SCHWEIZER SERVICE BULLETIN

C1B-020
29 Nov 2006

SUBJECT: SLICK SERVICE BULLETIN SB1-06A

SLICK SB1-06A

Figure 1

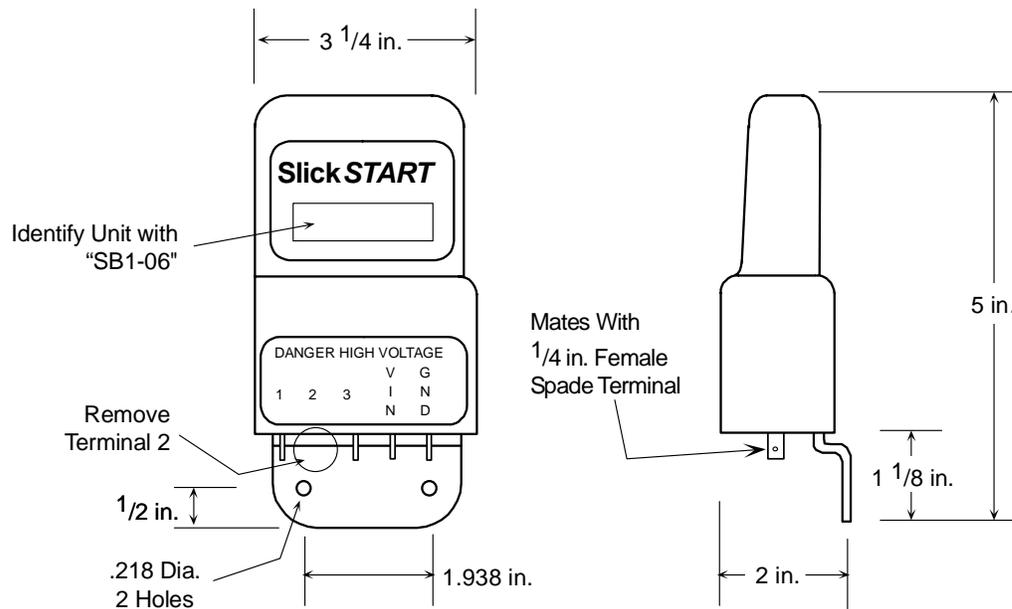
- If the SlickSTART™ unit is accessible, cut of the #2 pin as short as possible to prevent future use of this pin. See Figure 1. If necessary, remove the SS1001 from the firewall to complete this operation then re-install it.

Figure 2

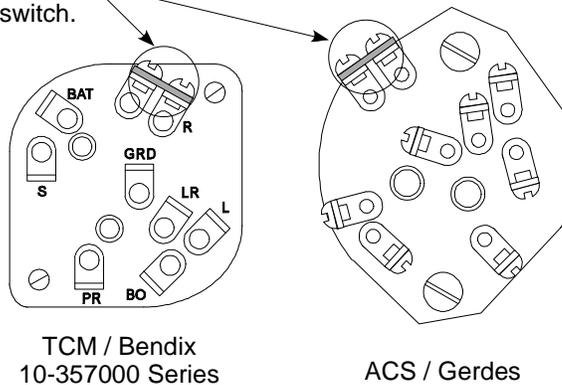
- A. In most applications, the right magneto can be grounded during start by the ignition switch. If the wiring connections on the back of the ignition switch are similar to those shown in Figure 2, a jumper can be added to the two terminals shown to provide a ground path during start.

Verify that this jumper is installed if your aircraft is equipped with this type of switch.
